September 19, 1984
PY-CEI/NRR-0138 L

Perry Nuclear Power Plant
Docket Nos. 50-440; 50-441
Response to NRC Question
Nos. 220.32 through 220.36 (480.54)-
Containment Drywell Wall Structural
and Bypass Leakage Integrity

PIPE SUPPORT MK-1H22-P015	044549-S-818-015	1001.2	2 OF 4	0
TITLE	DRAWING NUMBER	SHEET	PAGE	REV.

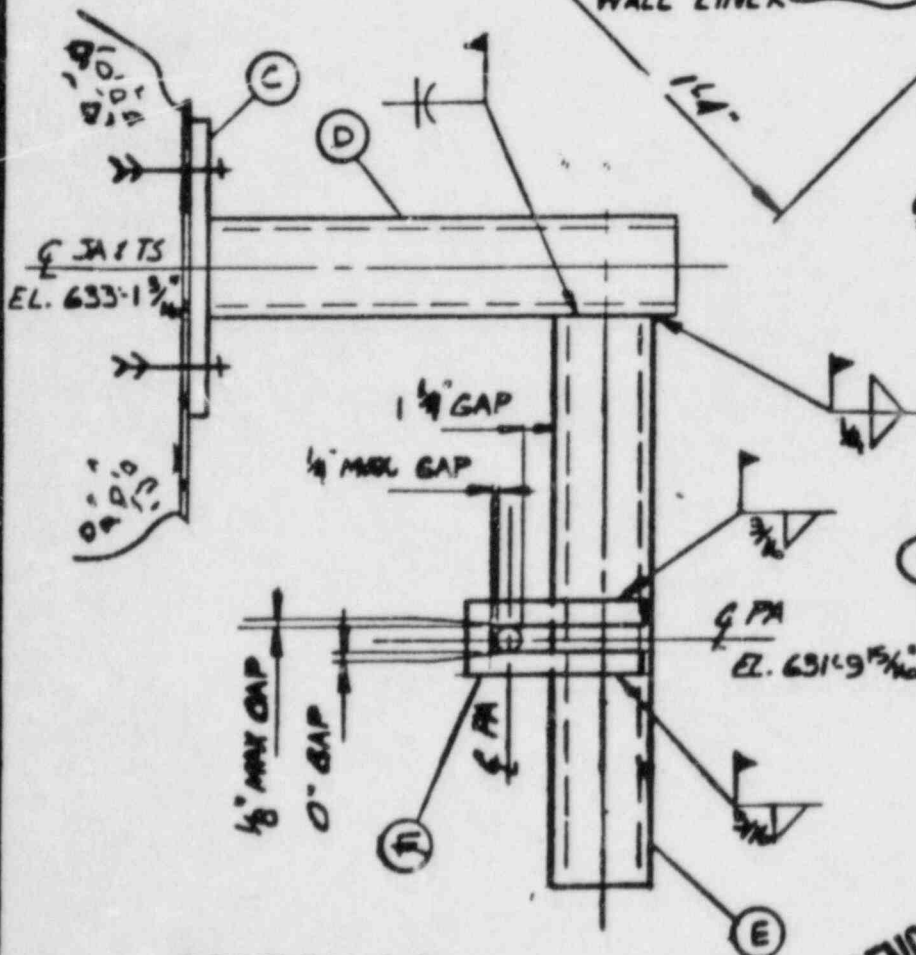
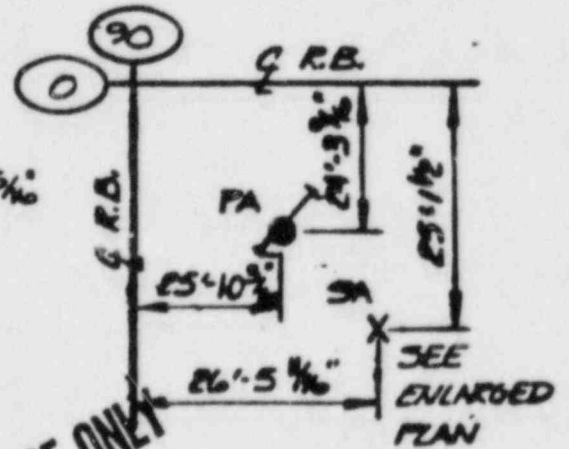
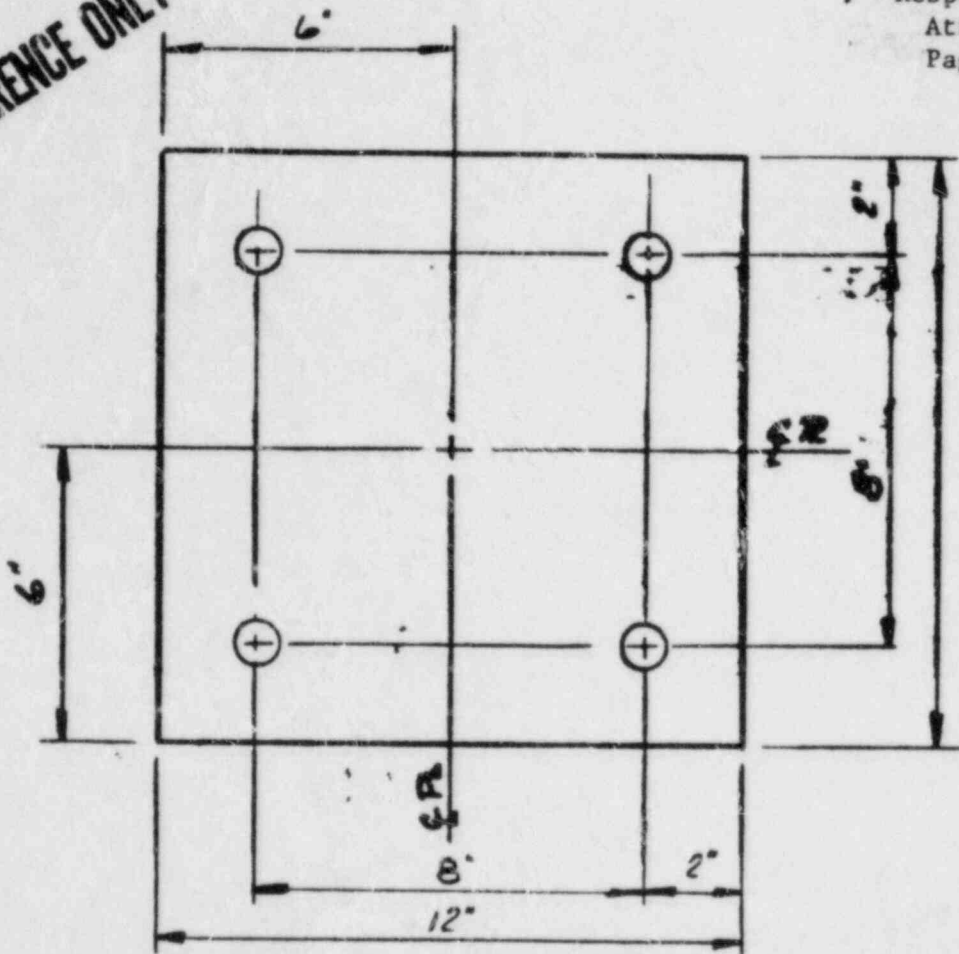
Q220.32: "Provide detail information on the installation of Hilti expansion concrete bolts in the drywell wall such as installing sequences, means for minimizing concrete cracks around the bolts, maximum size of bolt, procedures for achieving air tightness around the bolt, bolt patterns, maximum and minimum spacings of bolts, maximum bolt loads and capacity of the bolt."

Typical base plate details and patterns of installations through the drywell liner are shown on Attachment No. 2. Pages 1 through 3 of Attachment # 2 show a typical pipe support which uses one of several standard Hilti base plates.

These standard base plates are used by all disciplines. Page 4 of Attachment #2 shows the typical Hilti support detail used for conduit.
